PRELIM. CONSULT: 5921 Cedar Parkway<sup>M/P</sup>  
(Chevy Chase Village Historic District)

35/13-99Z 5921 Cedar Parkway  
(Chevy Chase Village HD)

**Address:** 5921 Cedar Parkway, Chevy Chase      **Meeting Date:** 11/17/99  
**Resource:** Chevy Chase Village Historic District      **Report Date:** 11/10/99  
**Review:** HAWP      **Public Notice:** 11/03/99  
**Case Number:** 35/13-99Z      **Tax Credit:** Partial  
**Applicant:** Jerome Powell and Elissa Leonard      **Staff:** Michele Naru  
(Stephen Muse, Agent)

**PROPOSAL:** Alterations to house.**RECOMMEND:** Approval.

NORTH ELEVATION  
SCALE: 1/4" = 1'-0"

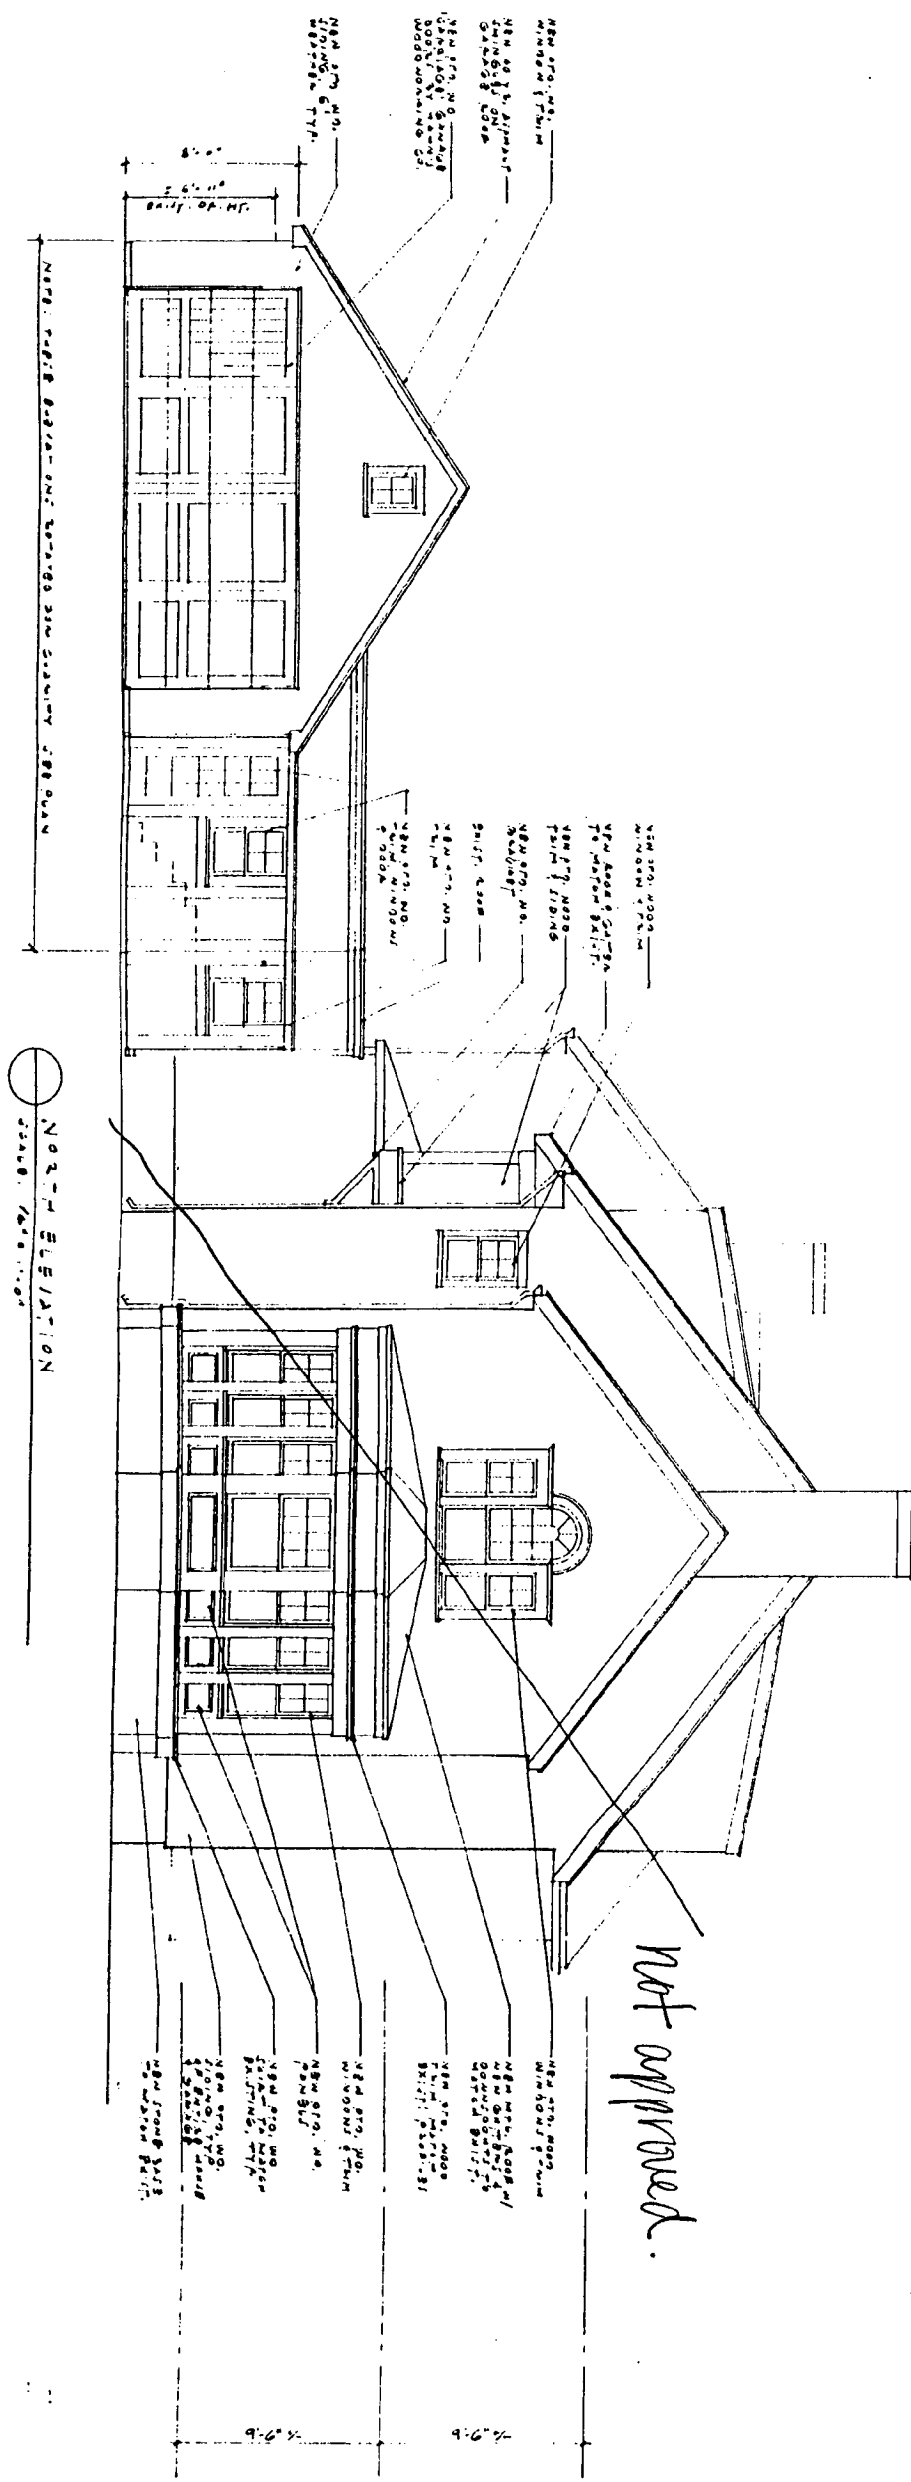
*not approved.*

X Approved with Conditions: ① THE ALTERNATE NORTH ELEVATION DESIGN IS USED.

ALTERNATE NORTH ELEVATION

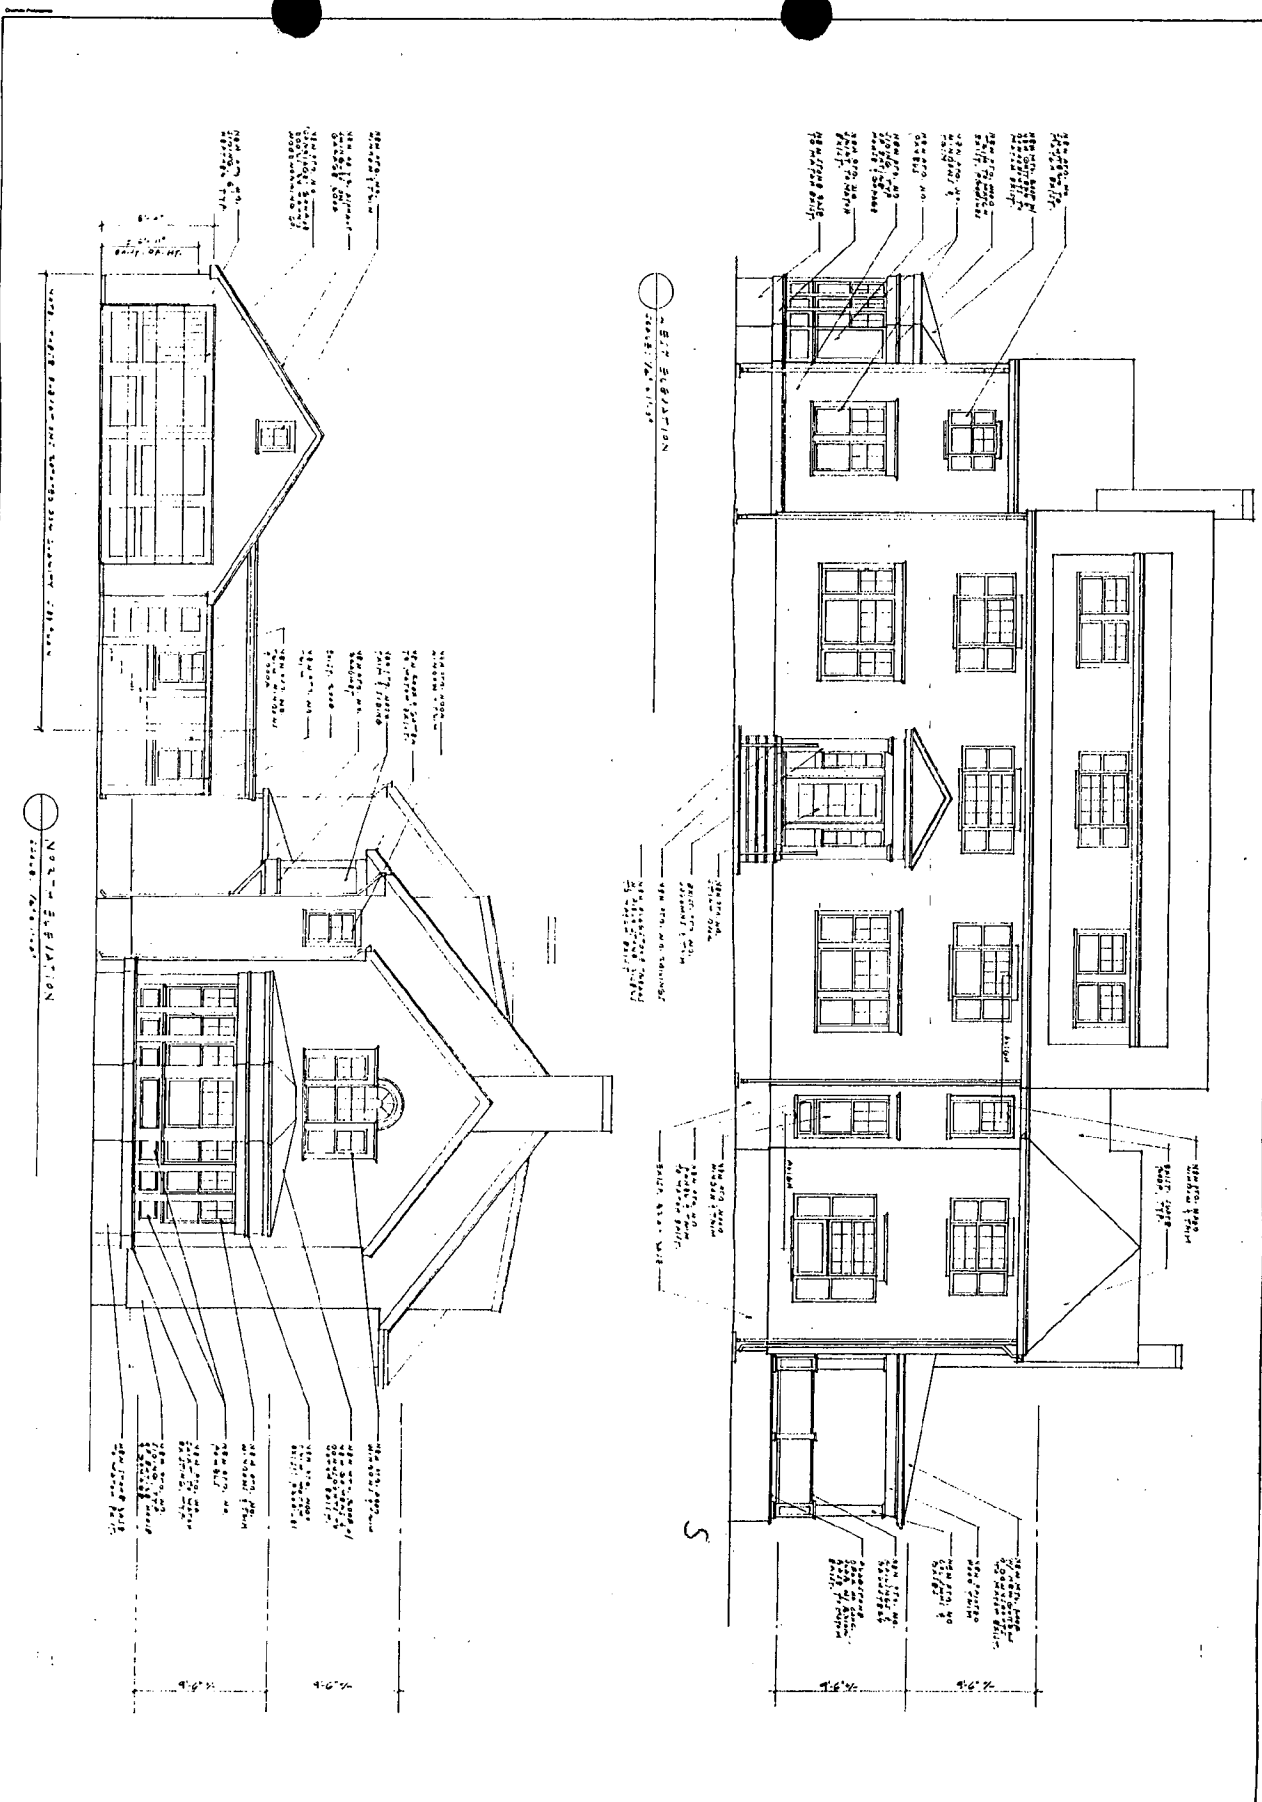
Approved 11/17/99  
(Expedited)  
w/ NORTH ELEVATION  
ALTERNATE PLAN.

1. Install a one-story bay on the first story of the extension. Remove the *out-of-period* second story windows and replace with two, 6/1 sash windows with paneled shutters (Circle 14). This window configuration is preferred to the Palladian configuration. The Palladian window treatment is not appropriate on a house that is Colonial Revival/Craftsman in style. The Palladian window is generally reserved for Adamesque house types.
2. Modify the connector (c.1974) between the garage and main section to include all new windows. Install a new door on the connector.
3. Replace the garage doors (c.1974) with paneled garage doors (Circle 13). Install an operable sash window in the garage's gable.
4. Remove the original second story window on the main block and replace with a 6/1 wood sash window.
